Date: 20th February 2018

**DA2017/0529 Harwood Slipway Pty Ltd T/A Harwood Marine
Development Proposal: Filling of land and shed for boat storage.**

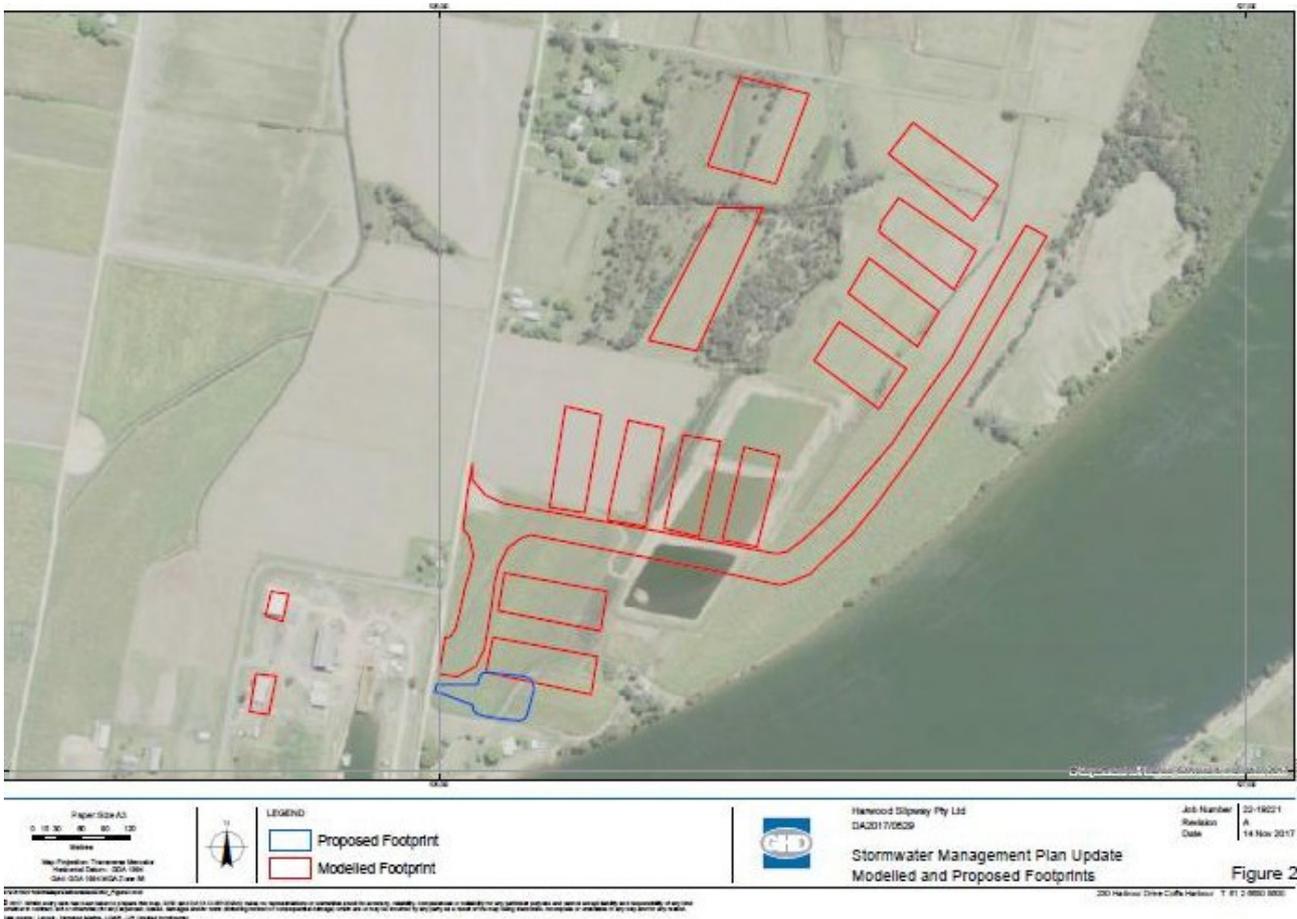
The image below, which is from the Stormwater Manage Plan, is also of great concern to us, as it shows the original plan for 10 pads, 2 of which are to be built on top of existing toxic waste ponds. But of more significance, is the proposal for **“Onsite Dams, with embankment at 20-yr ARI flood level”**, to be constructed between the two strips of E2 zoned land. We point out that this is, or should be (we understand the estuary entrance at the river has been illegally blocked), a tidal estuary and wetland complex that the proponent plans to dam.

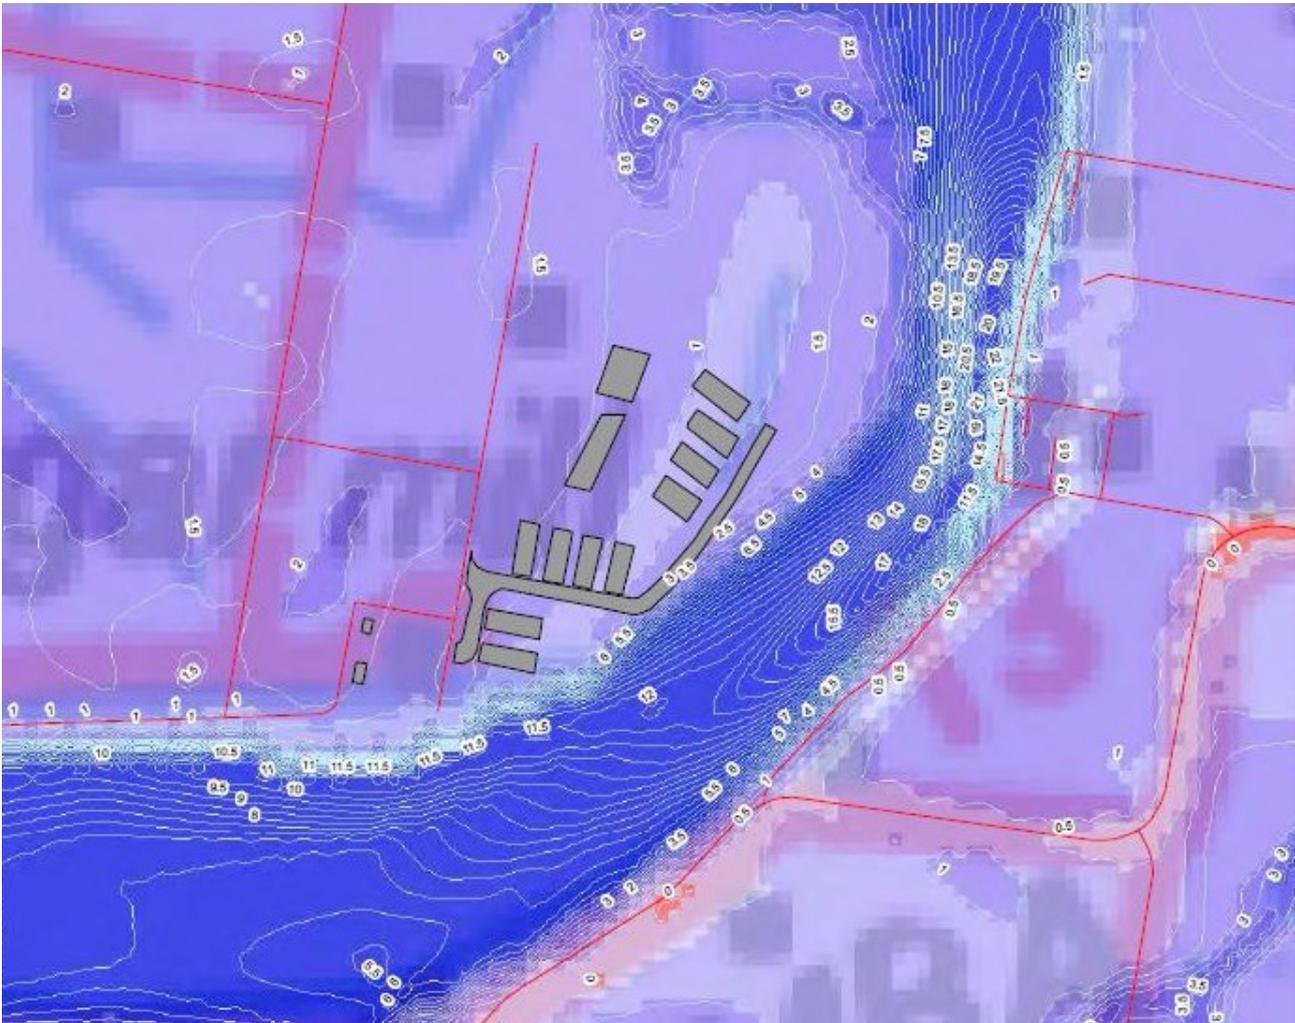
In terms of flood risks we draw attention to the following image from the Storm-water Management Plan, and note that all 10 pads and roadways are all to be constructed above the 1 in 100 year flood level. We believe that, as with the case of Southgate after the construction of the South Grafton levee wall, that flood flows could increase in speed and possibly be directed by the blockage, across the river and impact on residents on the river bank at Palmers Island.
